REMARKS

The present Amendment is in response to the Examiner's Office Action (hereinafter referred to as "Office Action") mailed September 8, 2005. Claims 1-20 were pending at the time of the last examination. By this amendment Claims 7 and 18 are cancelled, Claims 1, 8, and 12 are amended, and new Claims 21 and 22 are added. Claims 1-6, 8-17, and 19-22 are now pending in view of the above amendments.

Amendments to the Drawings:

Fig. 1

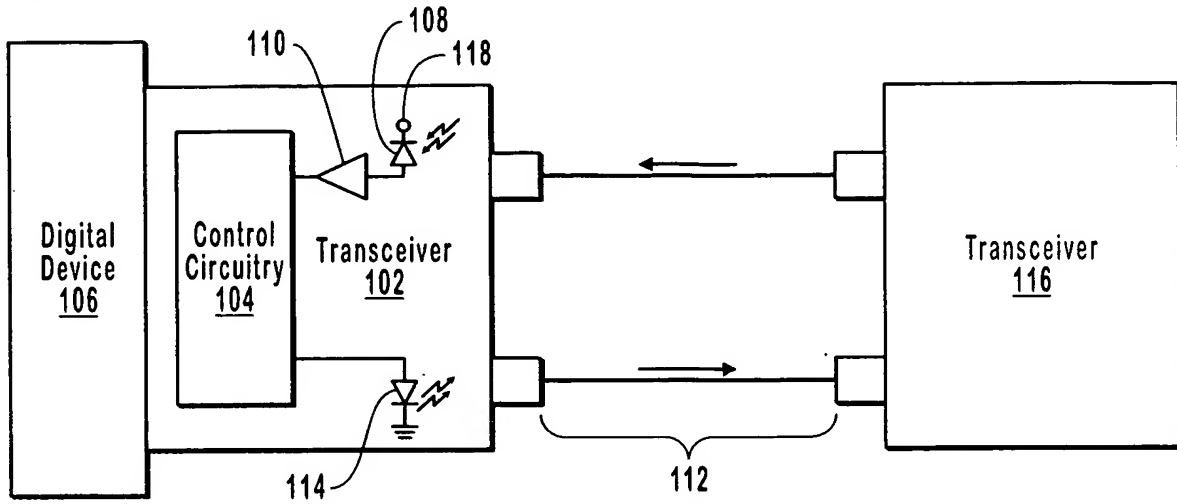
The Office Action in Section 1 objected to various drawings because block diagrams 104, 106, 116 in Figure 1, 232 in Figure 2, and 614 in Figure 6B were not labeled. Applicants submit new Figures 1, 2, and 6 which label the designated block diagrams. Also enclosed is a redlined copy of Figures 1, 2, and 6 showing the change being made.

Fig. 5

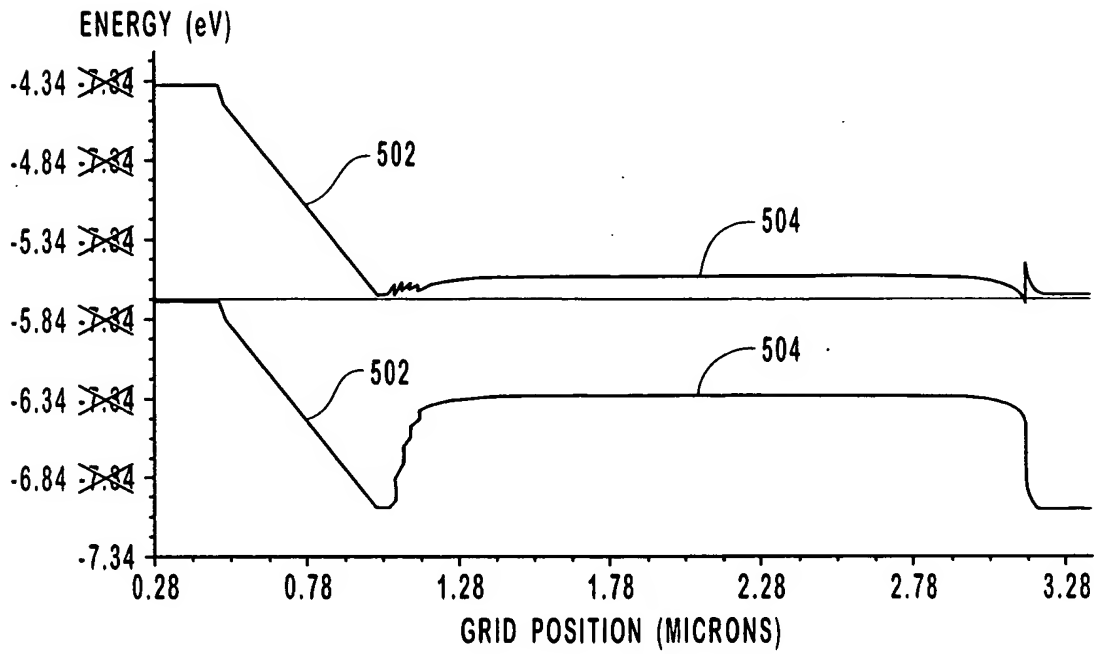
In addition, Section 1 of the Office Action objected to the vertical labeling of Figure 5. In response, Applicants have amended the vertical labeling so that the numbers are not the same. Applicants submit new Figure 5 with the amended vertical labeling. Also enclosed is a redlined copy of Figure 5 showing the change being made. Applicants note that no new matter has been added as the vertical labeling has been amended to match the vertical labeling of Figure 4 of U.S. Provisional Application No. 60/423,175, which was incorporated by reference by the pending application. Withdrawal of this ground of rejection is respectfully requested.

Fig. 6B

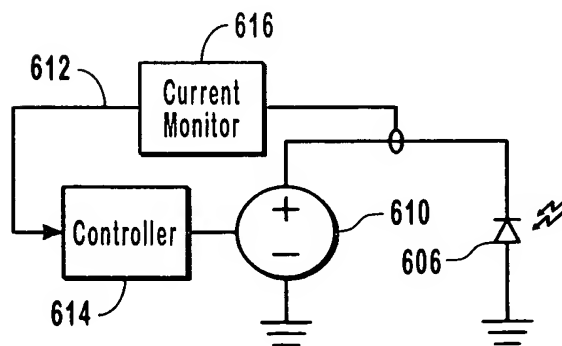
Applicants have further amended paragraph 46 to match amended Figure 6. Specifically the current monitor that was already discussed was given a label of "616" as in the amended
